T10/07-120r0 SAS-2 Transmitter De-Emphasis Measurement

**Serial
Attached
SCSI**

Diana Johnson and Mahbubul Bari

3/9/07

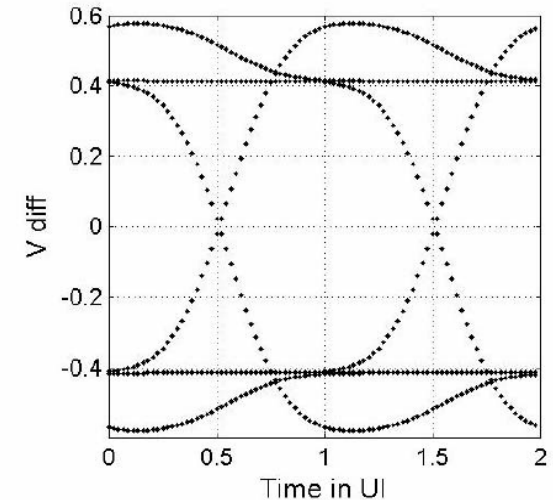
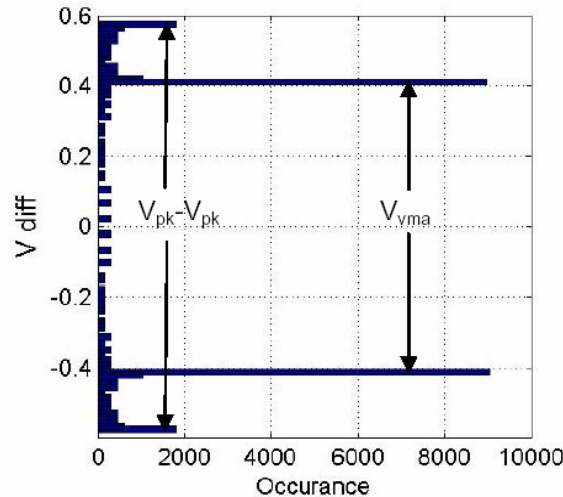
Method discussion

- Used two histogram
 - Top half
 - Bottom half
- Peak-to-peak value used
- V_{vma} – mode value used
- Clarify sample size – 1000/2000 or 10000

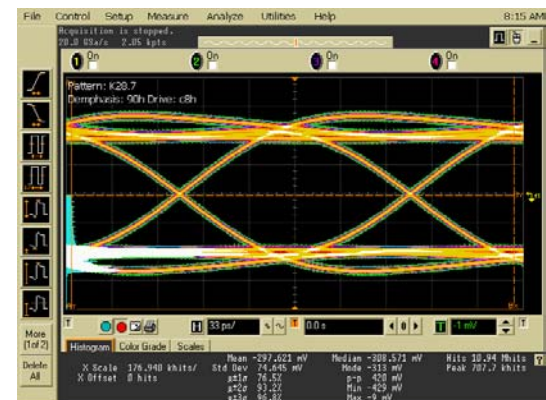
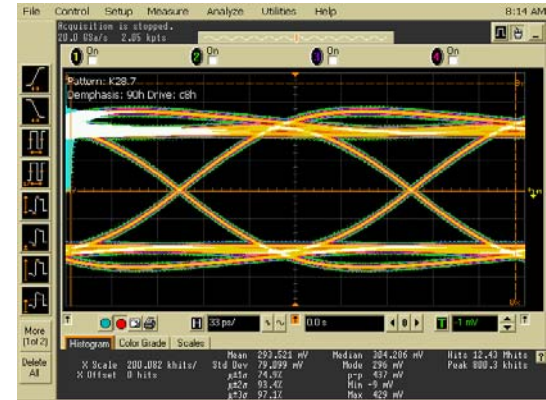
Measured values of De-Emphasis is pattern dependent

- We need to understand that the applied De-Emphasis is the same

-  Same De-Emphasis setting can show different measured value for different patterns due to their content and cause for confusion
